D3394-043
Job Sheet 208457

Part Name: Lug

DRAWING NO. D3394	TITLE LUG	REV. B	DART AEROSPACE LTD ENGINEERING ORDER		D.E.O. NO. D3394-B-1	SHEET NO. SHEET 1 OF 1	SCALE NTS
DRAWN AJS	CHECKED		MFG. APPR.	APPROVED		DE APPR.	
DATE 09.11.04	DATE 09.11.04		DATE 09.11.04	DATE 09.11.04		DATE 09.11.04

DRAWING NO.	D3394	TITLE	LUG	REV. B	DART AEROSPACE USA, INC	D.E.O. NO.	D3394-B-2	SHEET NO.	SHEET 1 OF 1	SCALE	NTS
DRAWN	<i>q</i>	CHECKED	<i>SC</i>	MFG. APPR.	<i>M</i>	APPROVED	<i>M</i>	DE APPR.	<i>W</i>		
DATE	11.05.02	DATE	11.25.07	DATE	11.05.08	DATE	11.25.08	DATE	11.05.09

D3394-1RG LUG (SHOWN)
D3394-3RG/-5RG LUGS (SIMILAR)
D3394-041RG/-043RG/-045RG LUG ASSEMBLIES (SIMILAR)

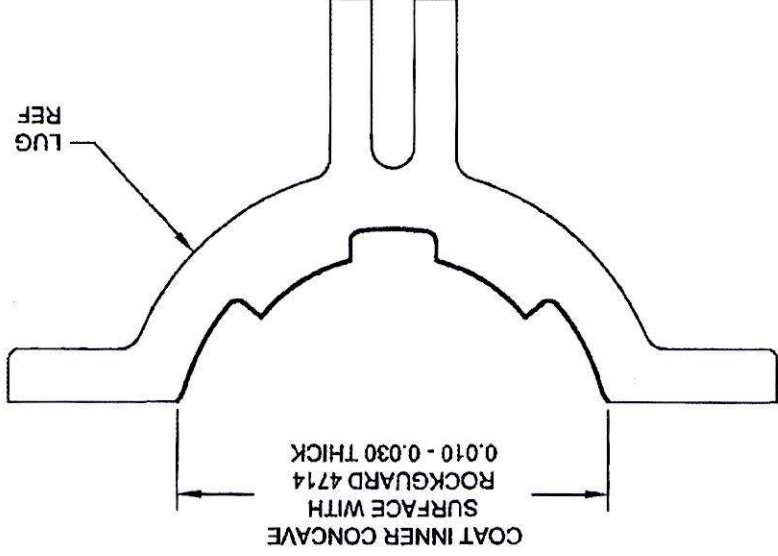
PURPOSE
ADD D3394-x-RG OPTION

CHANGE
D3394-x-RG MOUNTING LUGS ARE IDENTICAL TO D3394-x MOUNTING LUGS, HOWEVER AFTER FINISH, COAT INNER CONCAVE SURFACE WITH "PLUS ONE ROCKGUARD 4714" AS SHOWN BELOW.
